REMARKS

RESPONSE TO OFFICE
ACTION DATED DECEMBER 12, 2003

Atty. Docket No. 100-13202
(P04776-C2)

09/660,386

FIG. 1

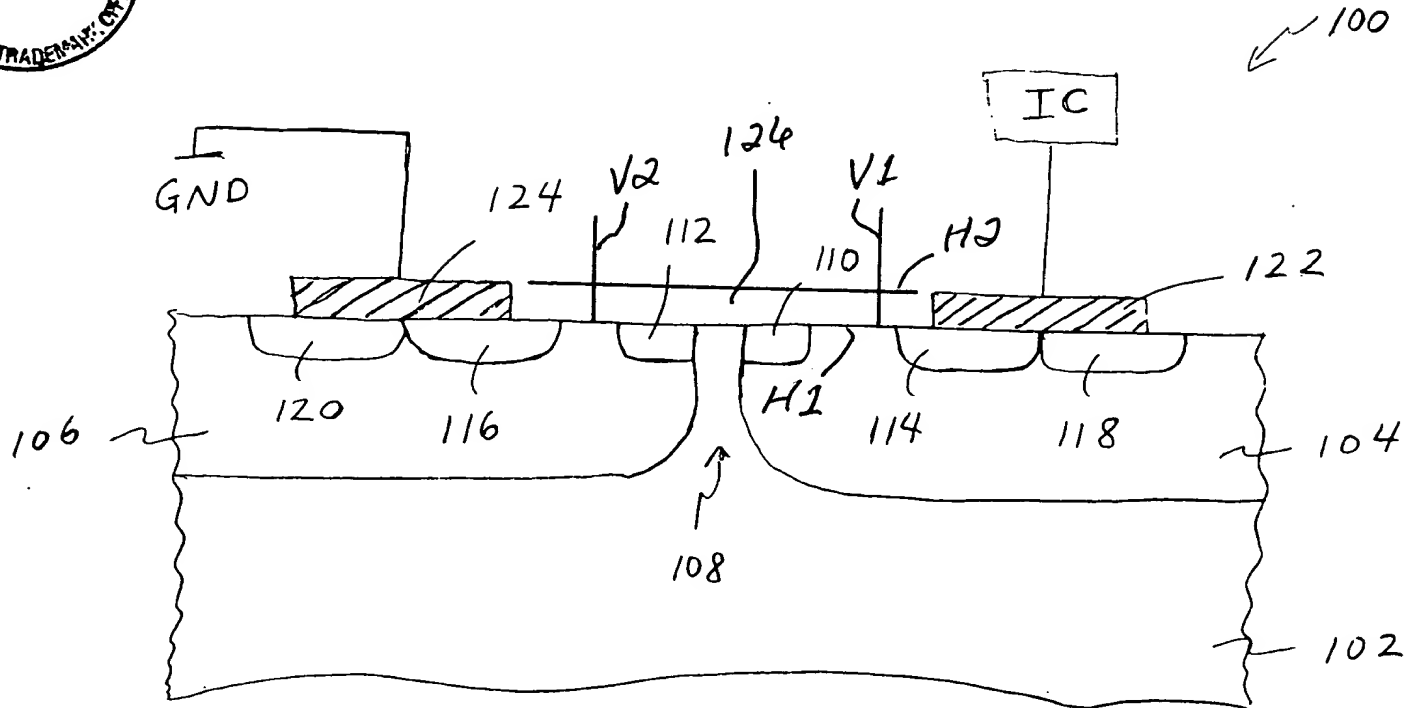
The Examiner objected to the drawings because FIG. 1 does not show the device region of the claims. FIG. 1 has been amended, as shown in red on the attached annotated marked-up drawing sheet of FIG. 1, and as shown in the attached replacement sheet of FIG. 1, to define a device region 126. In addition, the specification has been amended to define the device region 126. No new matter has been added. The replacement sheet of FIGs. 1 and 2, which is included in the Appendix along with the annotated marked-up drawing sheet of FIGs. 1 and 2, is to replace the formal sheet of FIGs. 1 and 2 mailed on September 4, 2002 and received by the Office on September 9, 2002.
